To: El Paso County
From: Brian Horan, PE, PTOE
Date: May 16, 2024
Re: **Owl Place Storage: Traffic Memorandum
El Paso County, CO**

Table 1
 Meridian Storage
 Site Trip Generation

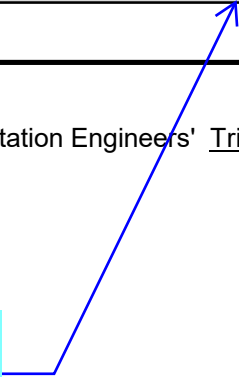
A right in only is proposed and will be allowed. Please revise the statement.

please clarify that this is the storage units and RV/boat spaces
